Purpose: The purpose is to fix issues with assertion VPI diagrams.

1. Clarify that `vpiIdentifier` iterator in the property and sequence declaration shall return the list of arguments in the declaration.
2. Add `vpiArgument` as an iterator to properties similar to sequences.

REPLACE in 36.43 Concurrent Assertions (note to editor: only the part that changes is shown)

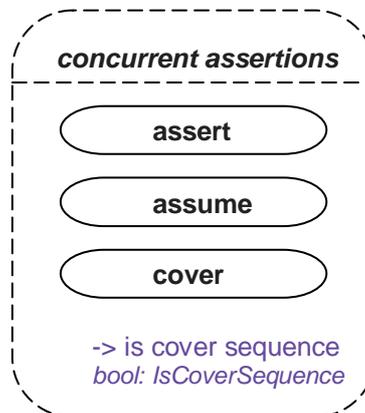
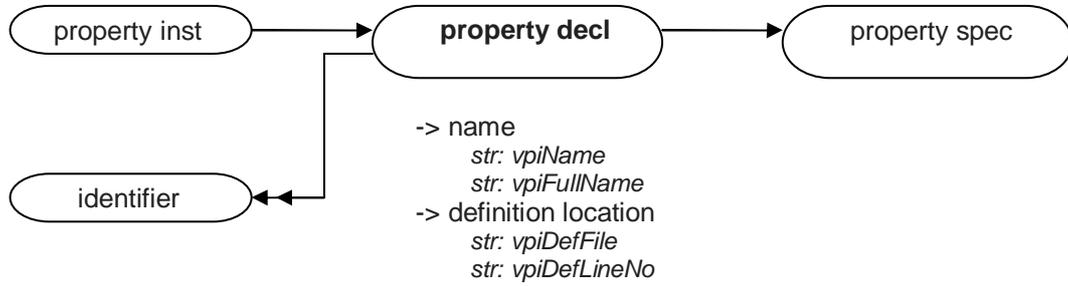
5. There is overlap in the definition of `vpiDefLineNo` and `vpiDef`. Add a note that they are the same for property and sequence declarations.
6. 'block identifier' makes no sense for sequence and property declarations. These are not 'labeled statements'. In diagram 36.43 and 36.46, 'block identifier' should be replaced with 'name'.

-> definition location
str: vpiDefFile
int: vpiDefLineNo
-> block identifier
str: vpiName
str: vpiFullName
-> is clock inferred
bool: vpilsClockInferred

-> definition location
str: vpiDefFile
int: vpiDefLineNo
-> ~~block identifier~~-name
str: vpiName
str: vpiFullName
-> is clock inferred
bool: vpilsClockInferred

IN 36.44 Property Declaration REPLACE

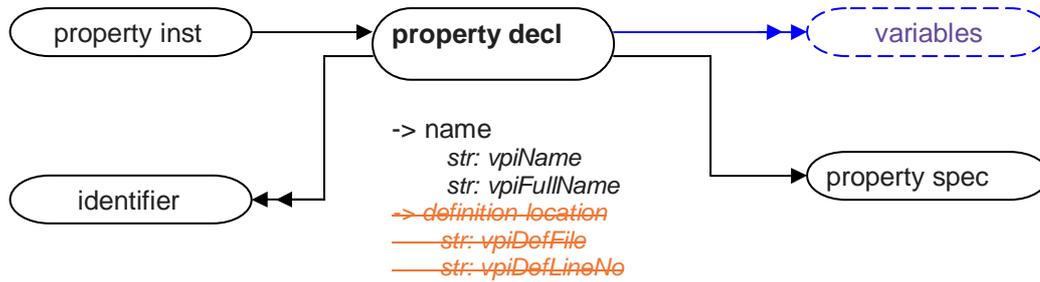
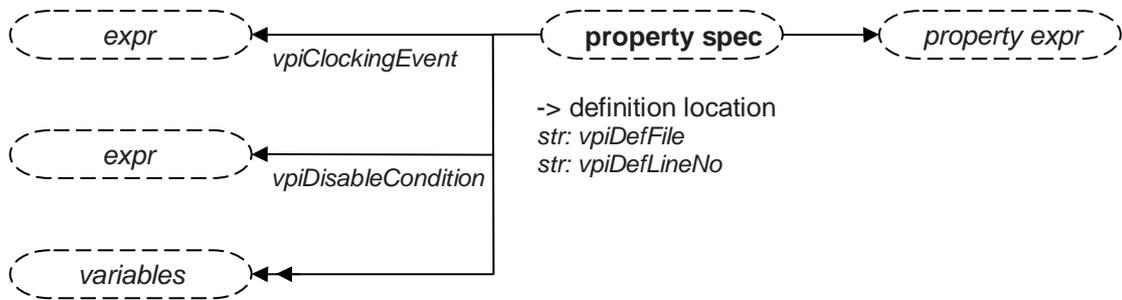
3. `vpiArgument` should be a `property_expr` for property instances and a `sequence_expr` for sequence instances (missed in Mantis 1730)
4. In several diagrams `vpiDefLineNo` is a “str”. This should be an “int”. It affect 36.44, 36.45, 36.46, 36.48.

7. `vpiArgument` should only come out of the sequence and property instance where they are defined (definitions are bold), so they should not be shown in the declaration diagrams.

- 1) The **vpiIdentifier** iterator shall return the property declaration arguments in the order that the formals for the property are declared.
- 2) **vpiDefFile** and **vpiDefLineNo** are deprecated because they are the same as **vpiLineNo** and **vpiFile**.

REPLACE in 36.47 Sequence Expression (only affected parts of the diagram are shown)

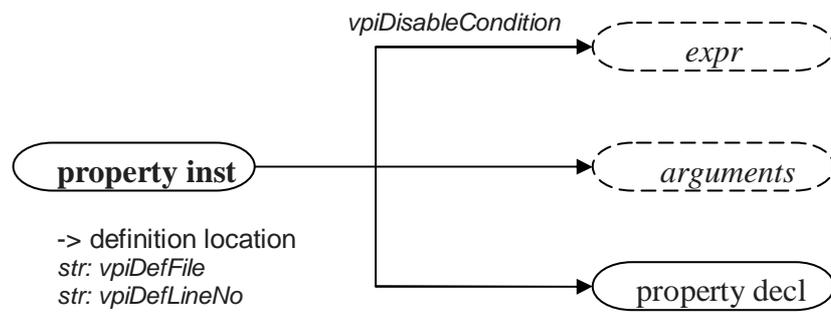
18. [DK] Updated 36.47 to remove the top sequence expr and re-position sequence declaration so the diagram looks like property inst.

1) The **vpiArgument** iterator shall return the sequence instance arguments in the order that the formals for the sequence are declared, so that the correspondence between each argument and its respective formal can be made. If a formal has a default value, that value shall appear as the argument should the instantiation not provide a value for that argument.

Move from “36.47 Sequence expression” the immediate assert definition to a new section titled “Immediate Assertions” that follows 36.48. The notes in 36.47 still remain only in 36.47 – they do not get copied. Note that immediate assume and immediate cover from Mantis 1729 will also reside in this new section. Re-number subsequent sections accordingly.

REPLACE from 36.48 Multiclock sequence expression (only the parts that change are shown)

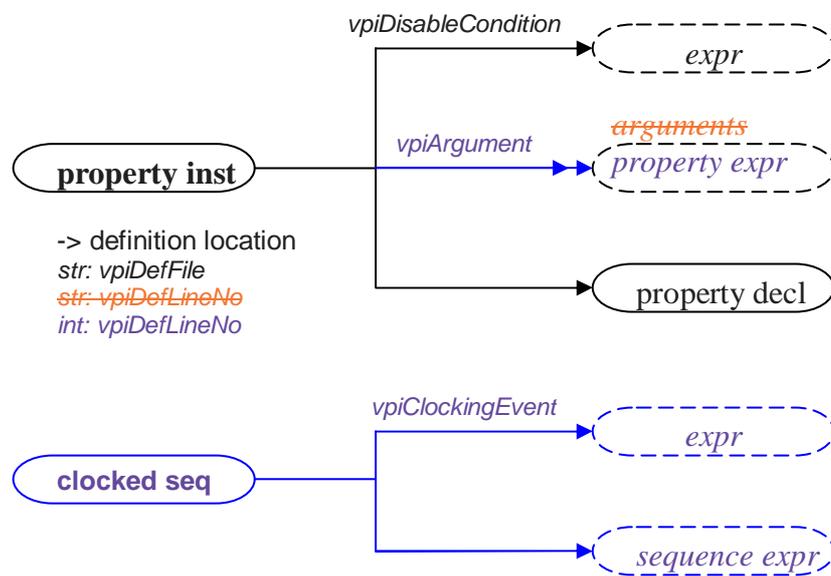
13. Added `vpiClockedSeq` diagram to 36.48

1) The **vpiArgument** iterator shall return the property instance arguments in the order that the formals for the property are declared, so that the correspondence between each argument and its respective formal can be made. If a formal has a default value, that value shall appear as the argument should the instantiation not provide a value for that argument.
